UH-1...

## Same Sheet with Pitch Link

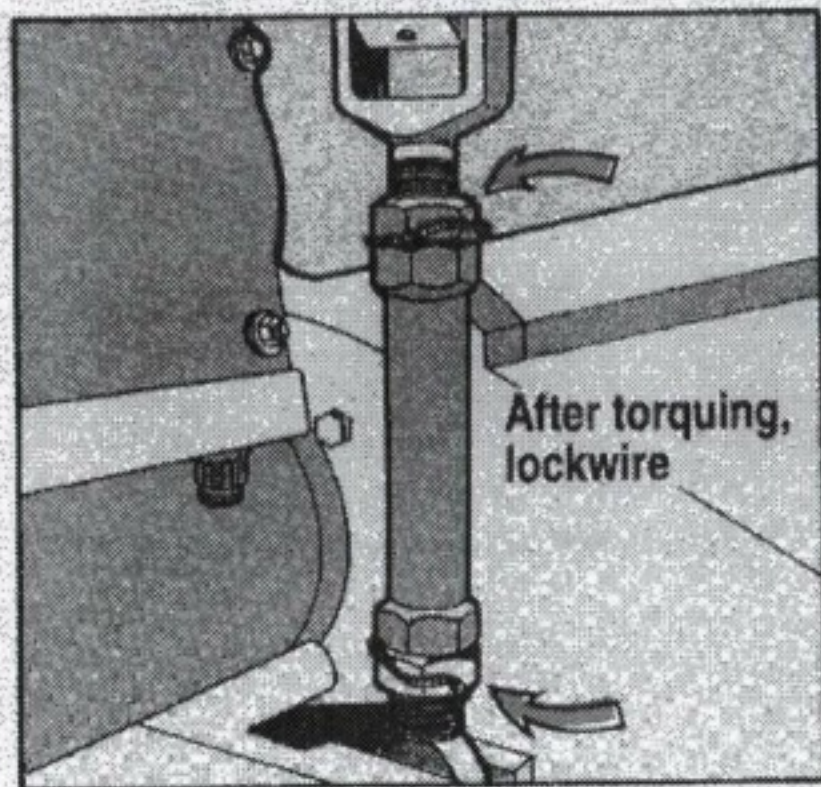
It's time everyone was on the same sheet of music concerning pitch link security.

A couple of years ago the bird head-shed said to forget about lockwiring the upper jam nut to the clevis when installing or adjusting the pitch chain links.

The current word is to follow Para 5-13.o.(5) of TM 55-1520-210-23-1. Lockwire the upper jam nut to both the barrel and the clevis and lockwire the lower jam nut to the barrel.
